ORDINANCE NO. _____

An ordinance amending Title 30 – Residential Code – of the Los Angeles County Code, by adopting and incorporating by reference the 2022 California Residential Code, with certain changes and modifications.

**FIGURE R403.1.5
STEPPED FOOTING**

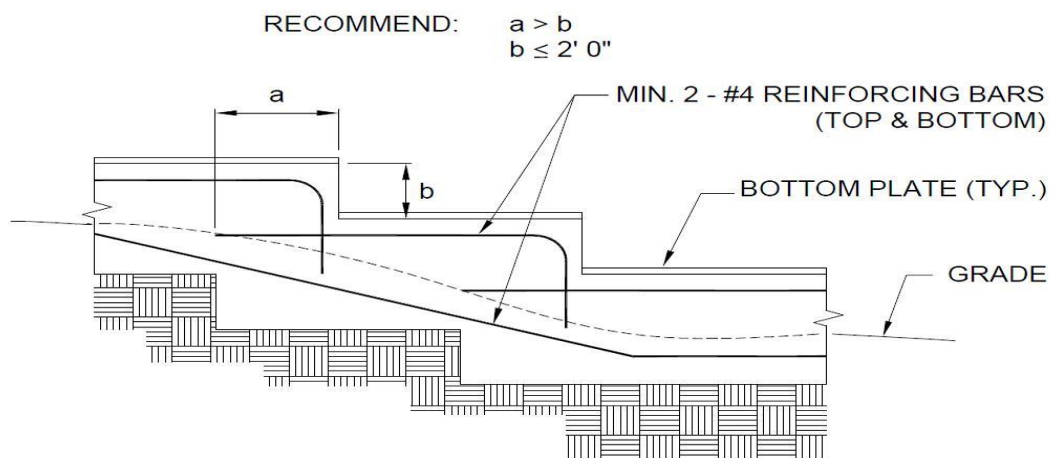
For structures located in Seismic Design Category D₀, D₁, or D₂, stepped footings shall be reinforced with two No. 4 reinforcing bars. Two bars shall be located at the top and bottom of the footings as shown in Figure R403.1.5.

SECTION 30. Figure R403.1.5 is hereby added to read as follows:

R403.1.5 Figure R403.1.5	Geological	California area. These amendments require minimum reinforcement in continuous footings and stepped footings to address the problem of poor performance of plain or under-reinforced footings during a seismic event. These amendments implement the recommendations of SEAOSC and the Los Angeles City Joint Task Force resulting from their investigation of the 1994 Northridge Earthquake. Interior walls can easily be called upon to resist over half of the seismic loading imposed on simple buildings or structures. Without a continuous foundation to support the braced wall line, seismic loads would be transferred through other elements such as non-structural concrete slab floors, wood floors, etc. Requiring interior braced walls to be supported by continuous foundations is intended to reduce or eliminate the poor performance of buildings or structures.
R404.2	Climatic Geological	No substantiating data has been provided to show that wood foundations are effective in supporting structures and buildings during a seismic event while being subject to deterioration caused by the presence of water and other materials detrimental to wood foundations in the soil. Wood foundations, when they are not properly treated and protected against deterioration, have performed very poorly and have led to slope failures. Most contractors are typically accustomed to construction in dry weather in the Southern California region and are not generally familiar with the necessary precautions and treatment of wood that makes it suitable for both seismic events and wet applications. With the higher seismic demand placed on buildings and structures in this region, coupled with the dryer weather conditions, it is the intent of this amendment to reduce or eliminate potential problems resulting from the use of wood footings and foundations.

FIGURE R503.2.4

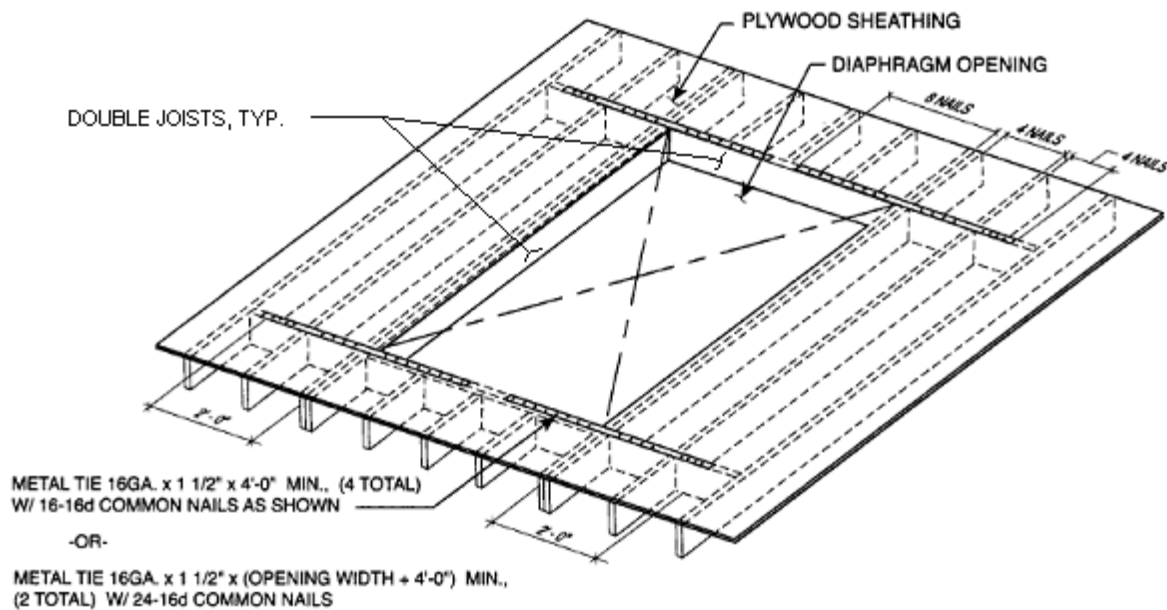
Openings in horizontal diaphragms with a dimension perpendicular to the joist that is greater than 4 feet (1.2 m) shall be constructed in accordance with Figure R503.2.4.

SECTION 34. Figure R503.2.4 is hereby added to read as follows:

- a. Blockings shall be provided beyond headers.
- b. Metal ties not less than 0.058 inch [1.47 mm (16 galvanized gage)] by 1.5 inches (38 mm) wide with eight 16d common nails on each side of the header-joist intersection. The metal ties shall have a minimum yield of 33,000 psi (227 MPa).
- c. Openings in diaphragms shall be further limited in accordance with Section R301.2.2.6.

**FIGURE R602.10.6.1
METHOD ABW—ALTERNATE BRACED WALL PANEL**

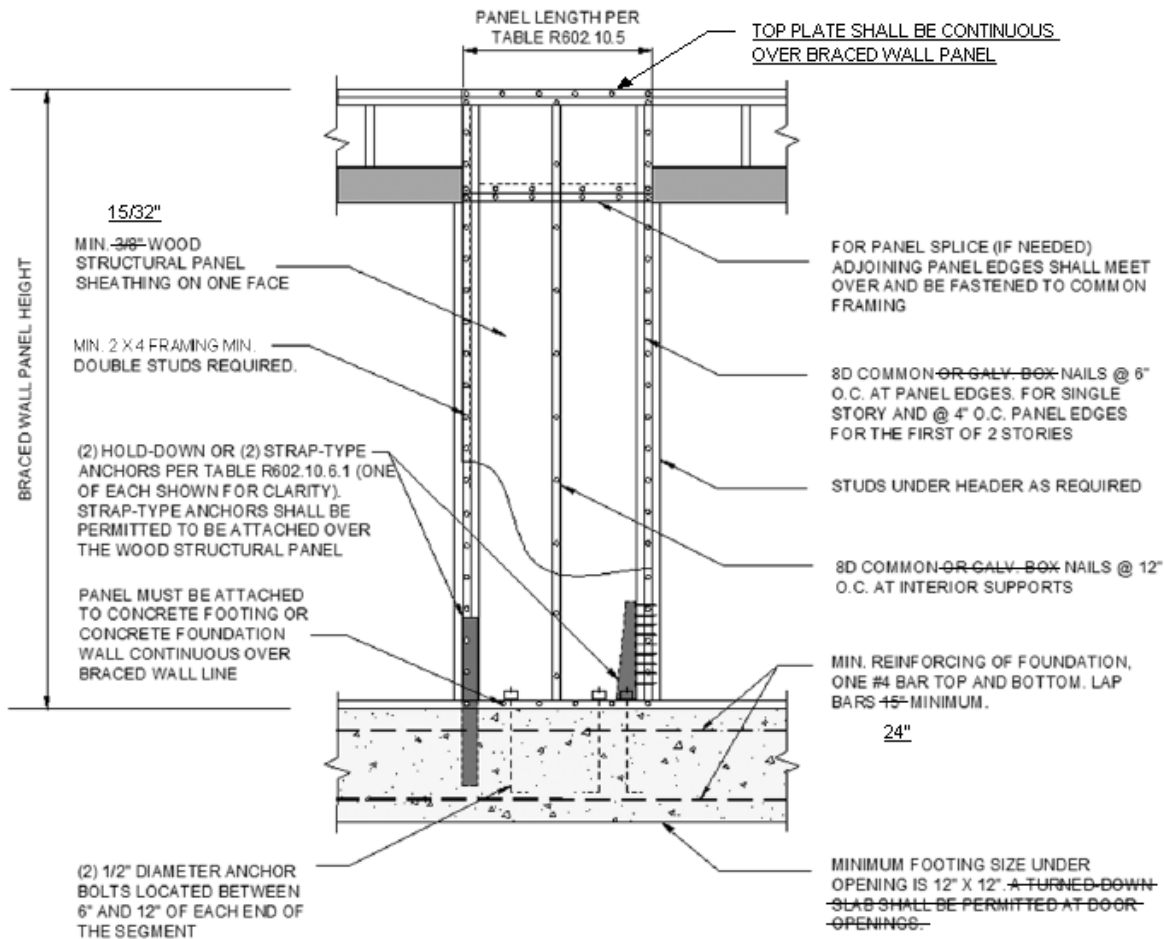
Figure R602.10.6.1 is amended to read as follows:

shear walls when designed for high levels of seismic loads. The performance of modern day braced wall panel construction is directly related to an adequate load path extending from the roof diaphragm to the foundation system.
Figure R602.10.6.2	Geological	3/8" thick 3 ply-plywood shear walls experienced many failures during the Northridge Earthquake. The poor performance of such shear walls in the 1994 Northridge Earthquake was investigated by SEAOSC and the Los Angeles City Joint Task Force. The County of Los Angeles and cities in this region have taken extra measures to maintain the structural integrity of the framing of the shear walls when designed for high levels of seismic loads. Box nails were observed to cause massive and multiple failures of typical 3/8-inch thick plywood during the Northridge Earthquake. This change to the minimum lap splice requirement is consistent with Section 12.16.1 of ACI 318-11. This amendment is a continuation of amendments adopted during prior Code adoption cycles.

FIGURE R602.10.6.2
METHOD PFH—PORTAL FRAME WITH HOLD-DOWNS
AT DETACHED GARAGE DOOR OPENINGS

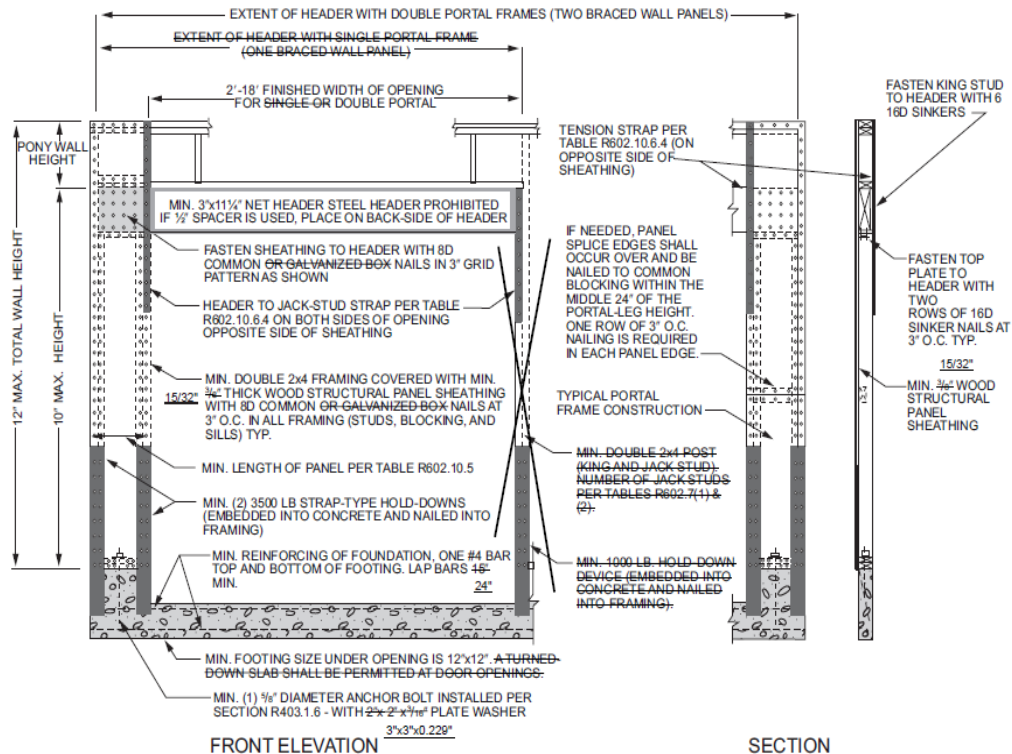
SECTION 44. Figure R602.10.6.2 is hereby amended to read as follows:

FIGURE R602.10.6.4
METHOD CS-PF—CONTINUOUSLY SHEATHED PORTAL FRAME PANEL CONSTRUCTION

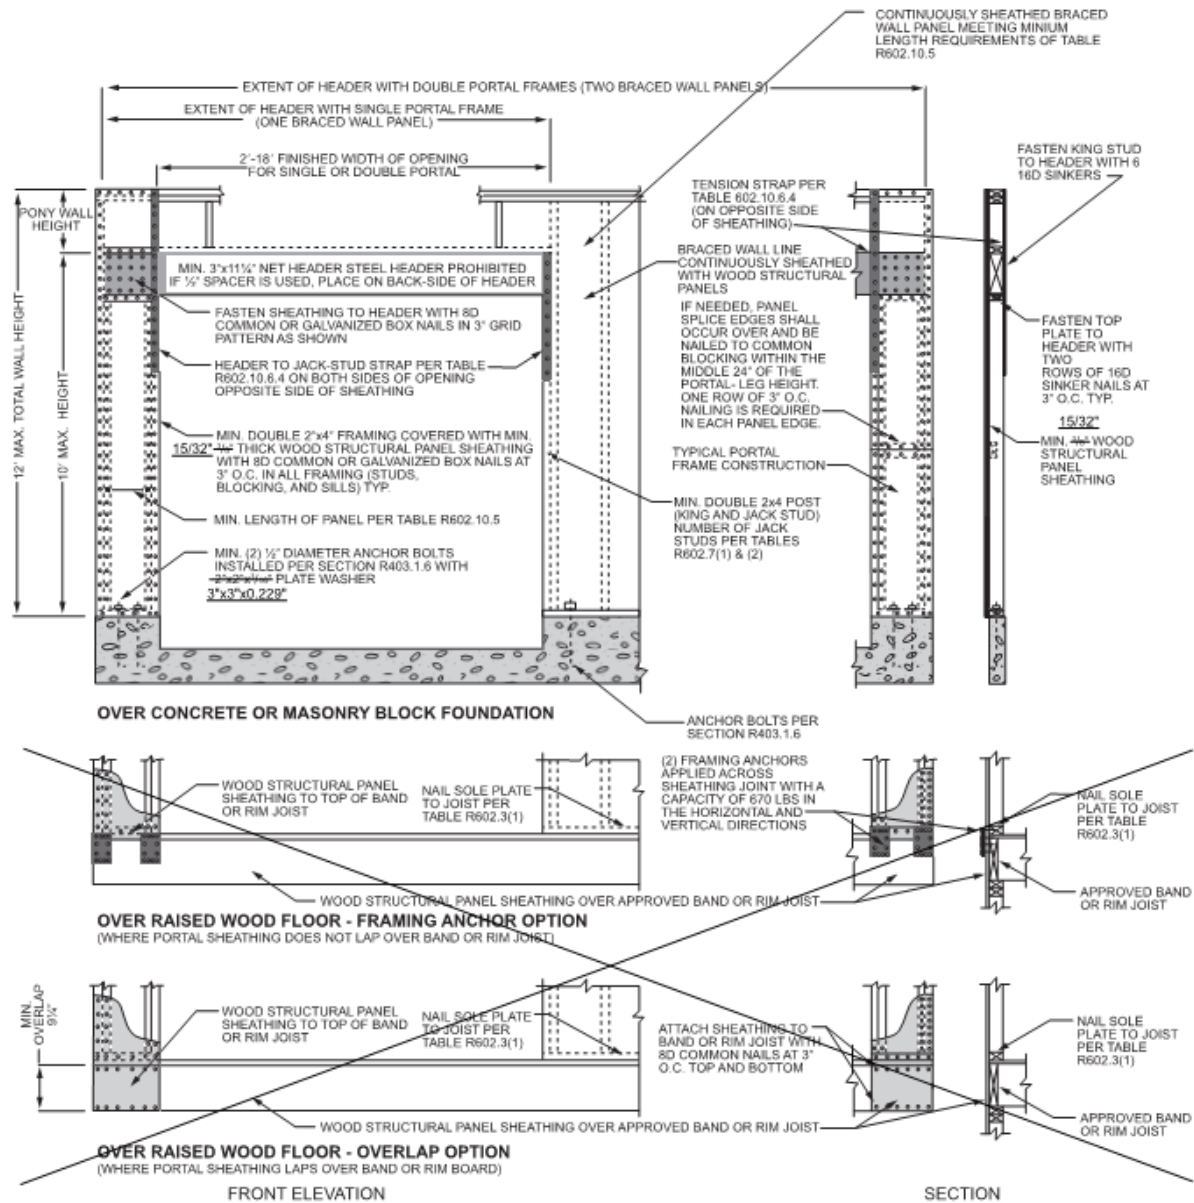
Figure R602.10.6.4 is hereby amended to read as follows:

Figure R602.10.6.4	Geological	3/8" thick 3 ply-plywood shear walls experienced many failures during the Northridge Earthquake. The poor performance of such shear walls in the 1994 Northridge Earthquake was investigated by SEAOSC and the Los Angeles City Joint Task Force. The County of Los Angeles and cities in this region have taken extra measures to maintain the structural integrity of the framing of the shear walls when designed for high levels of seismic loads. The proposal in which "washers shall be a minimum of 0.229 inch by 3 inches by 3 inches in size" is consistent with Section R602.11.1 of the California Residential Code and Section 2308.3.1 of the California Building Code. This amendment is a continuation of amendments adopted during prior Code adoption cycle.
R606.4.4	Geological	Los Angeles County is prone to seismic activity due to the existence of active faults in the Southern California area. The addition of the word "or" will prevent the use of unreinforced parapets in Seismic Design Category D ₀ , D ₁ or D ₂ , or on townhouses in Seismic Design Category C.
